January 30, 2006

Project Texas Roadhouse Madison, WI
Project # 20050922.2
Re Resubmittal: Urban Design Review

Please note the following revisions to the documents listed above:

WI-50922A5

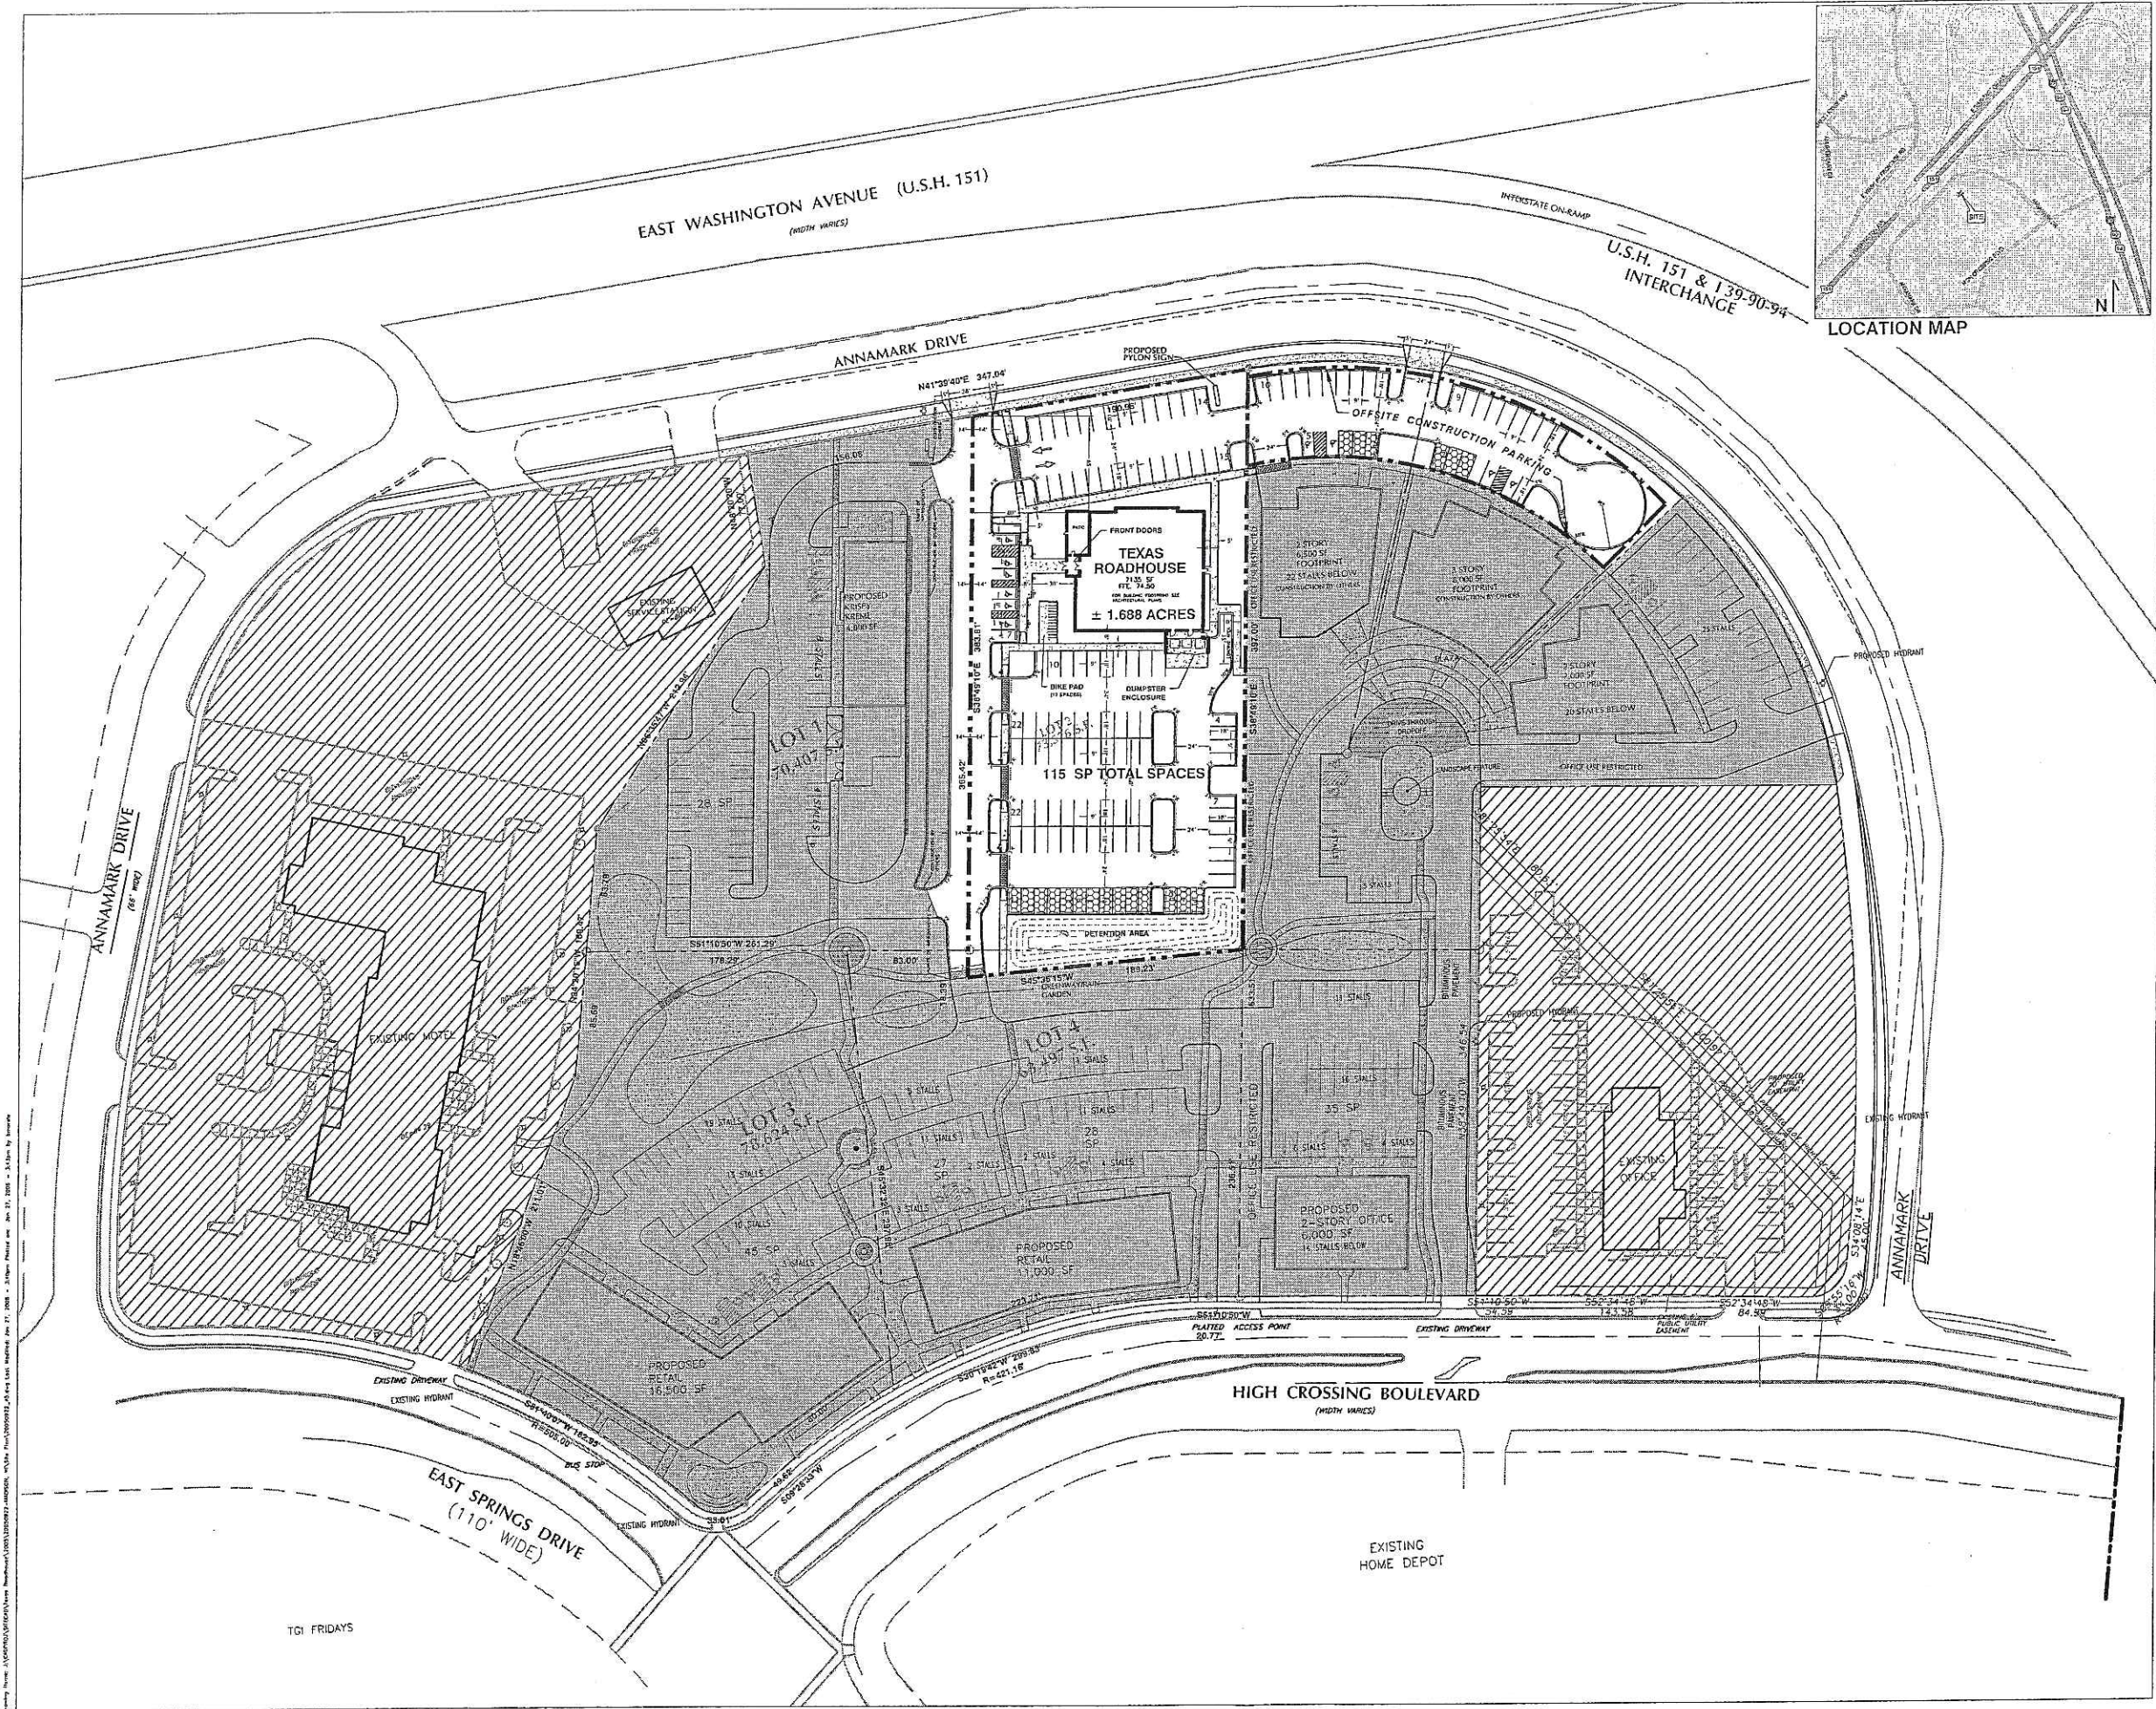
5. The site plan has been revised to add permeable pavement for the fourteen (14) parking stalls by the detention area and six (6) spaces in the off-site parking area.

SITE LIGHTING PLAN

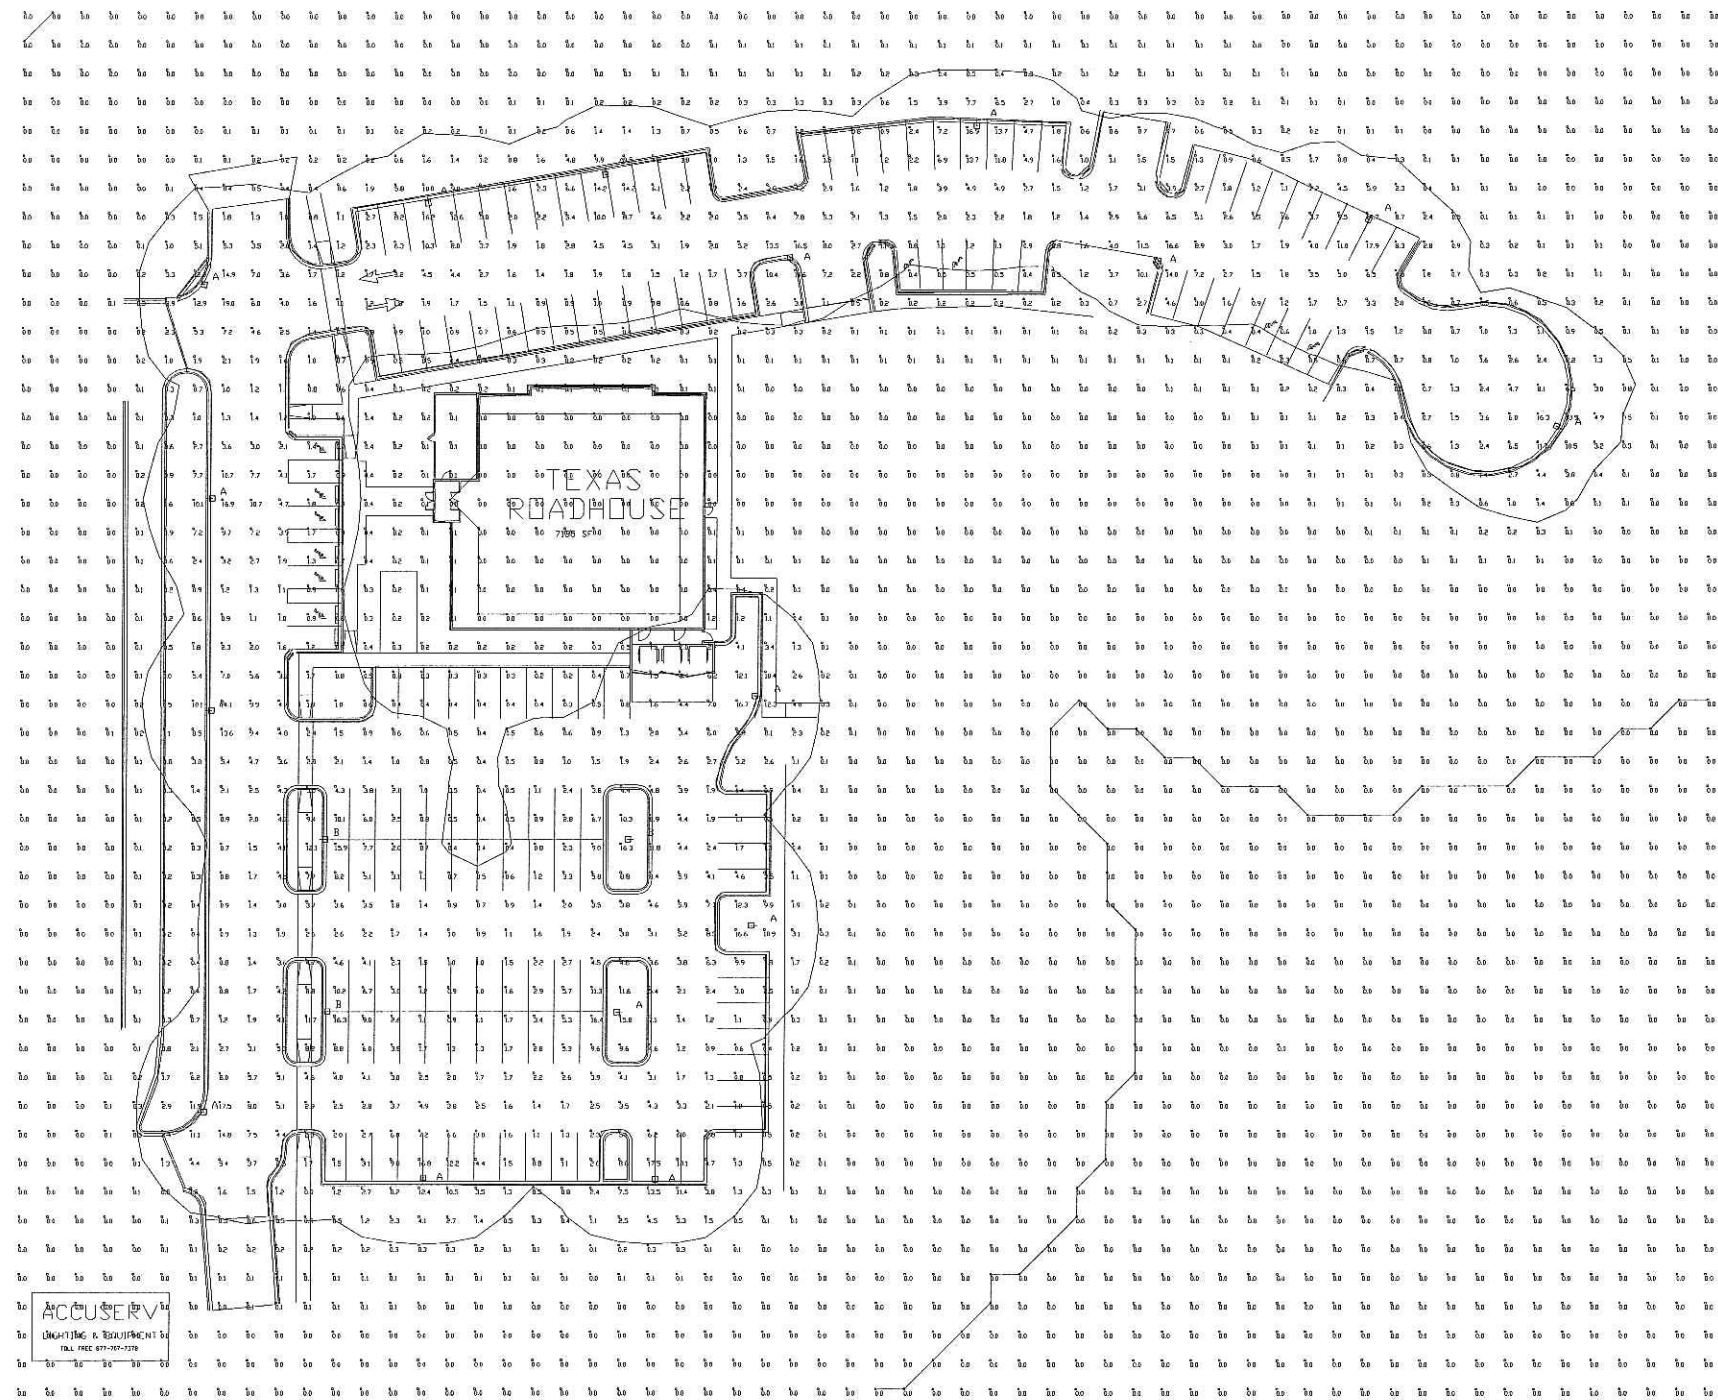
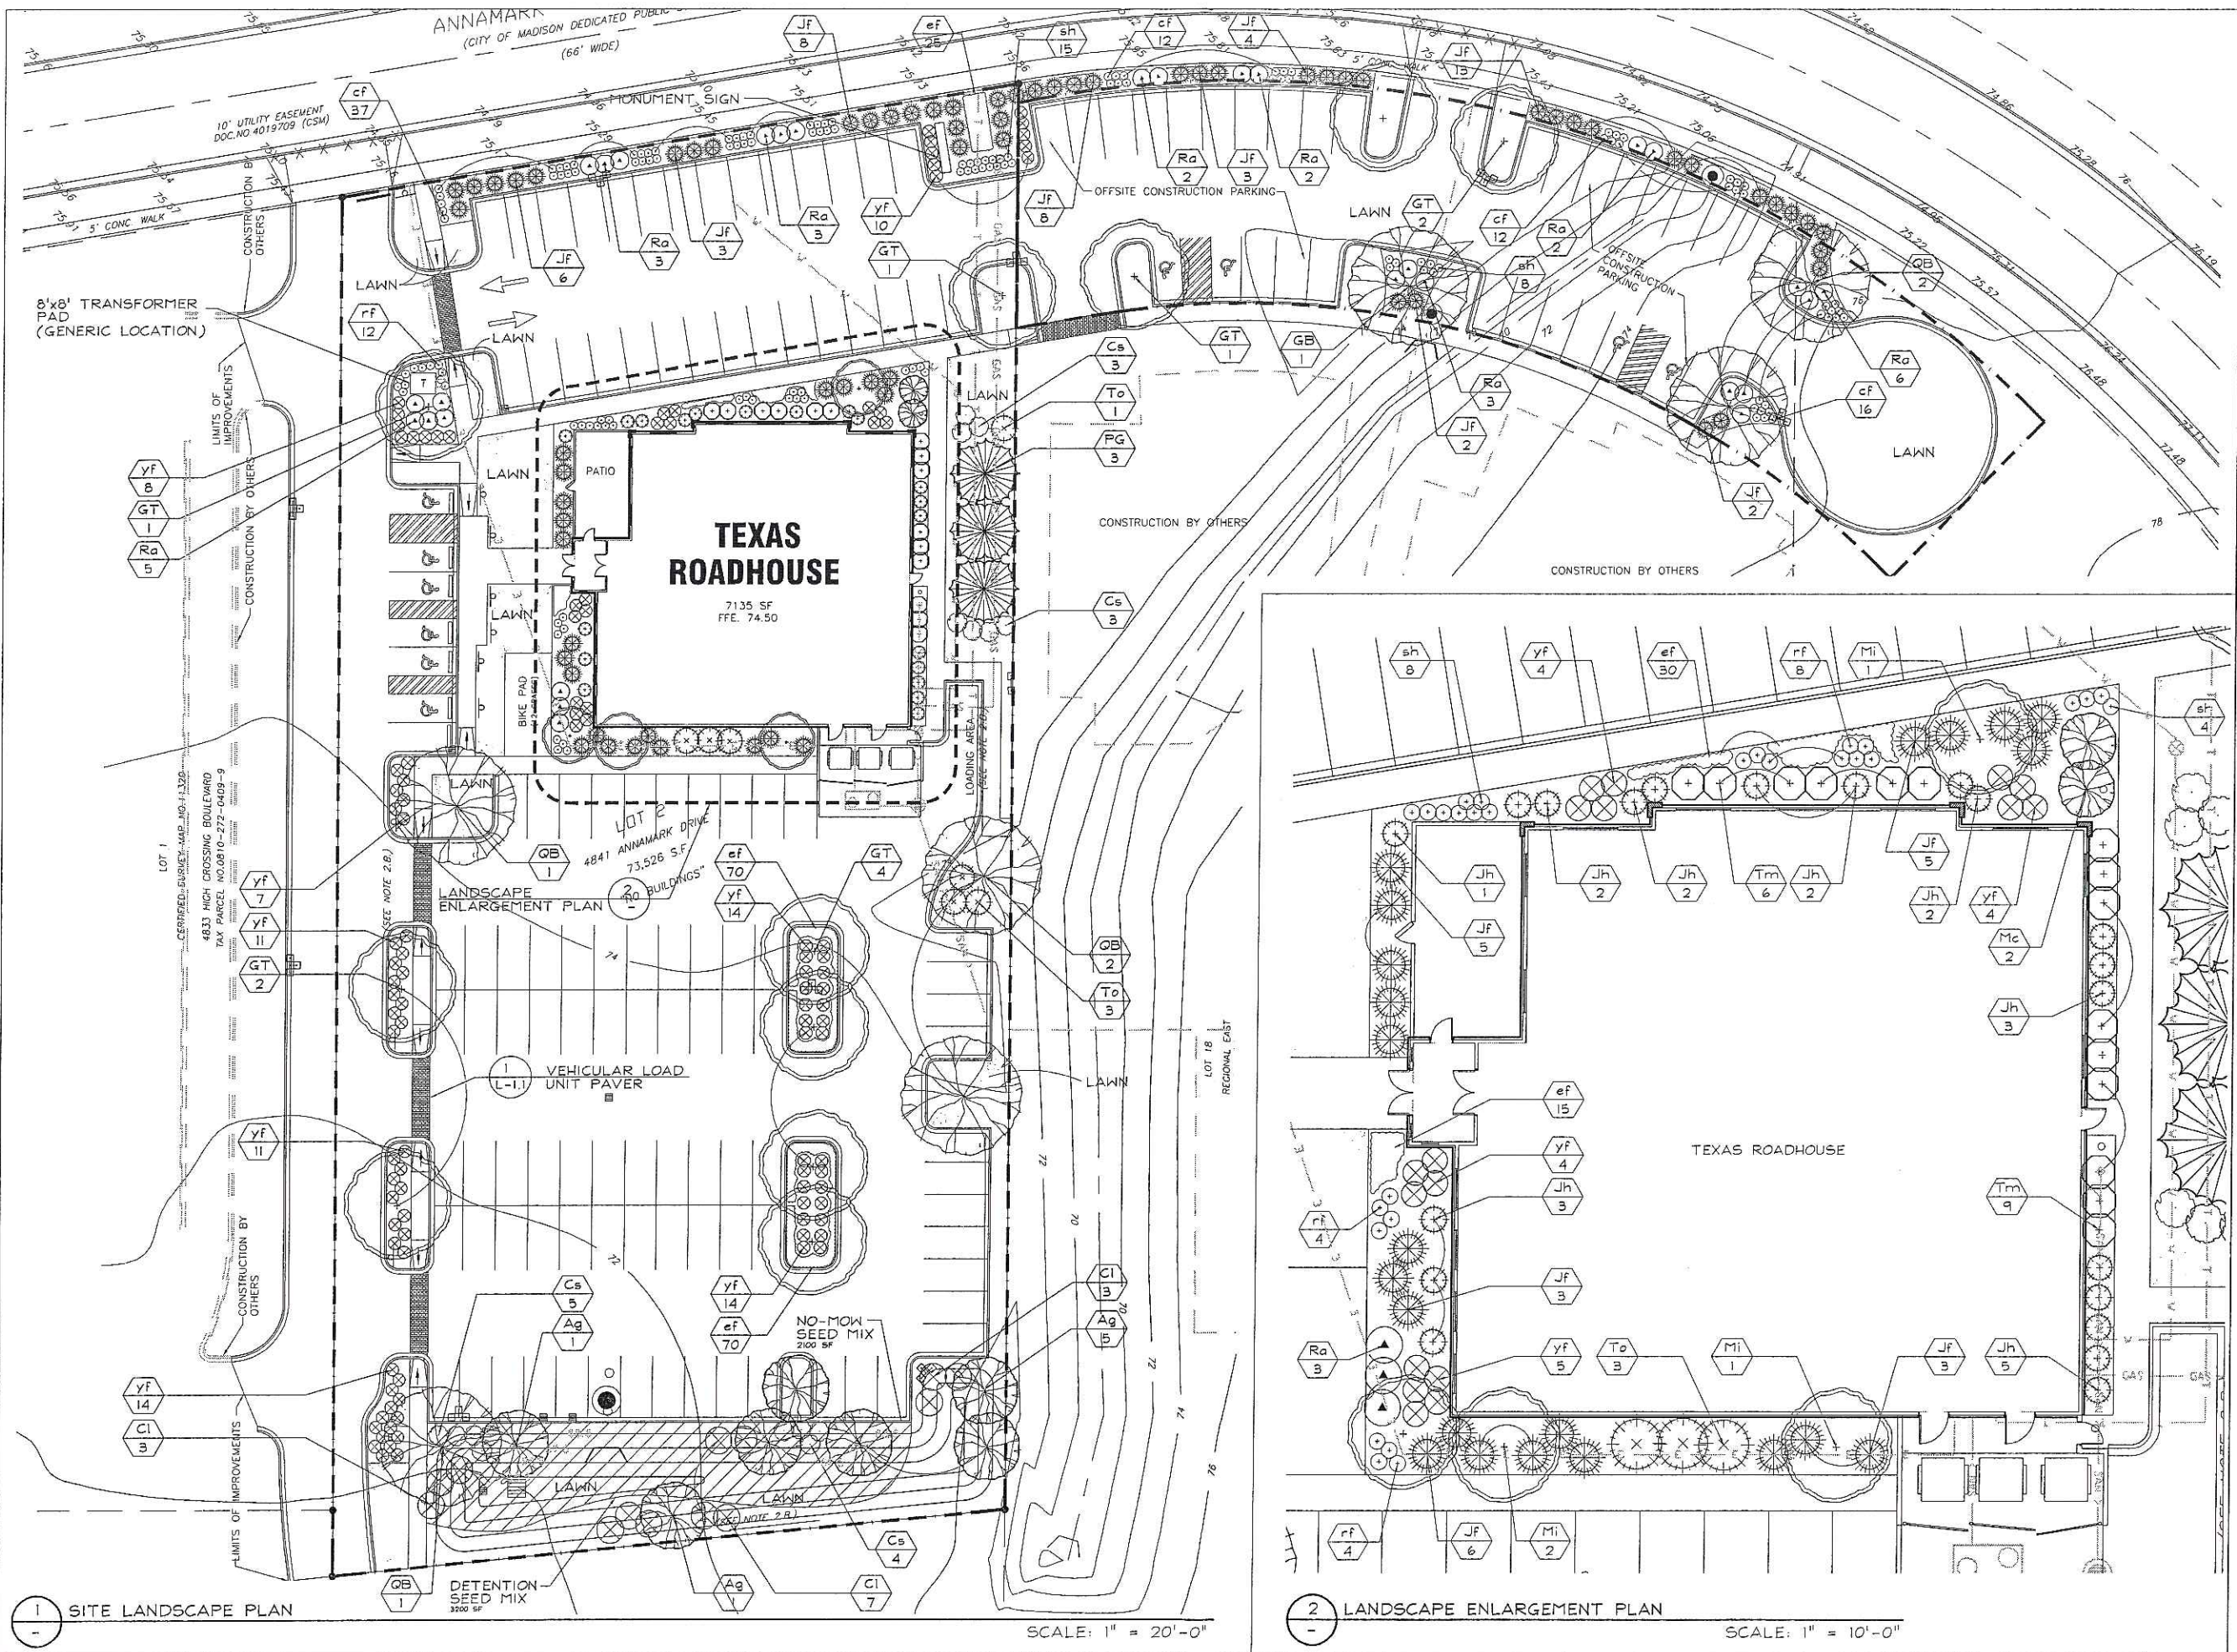
1. The photometric plan (Sheets C7.0 & C7.1 of the Civil Engineering Plan Set) has been revised to reduce the overall site lighting height from 27.5 ft. to 22.5 ft. (20' pole plus 2.5' base). Light levels have been adjusted accordingly and are more uniform throughout the site, thus reducing "hot spots."
2. Building exterior lighting has been revised to:
 - Eliminate the floodlights that up-light the roof and flags.
 - Eliminate the LED stripe that outlines the building.
3. Remaining building exterior lighting is as follows:
 - 100-175 watt MH wall packs at emergency exits (Cut Sheet "Type F12").
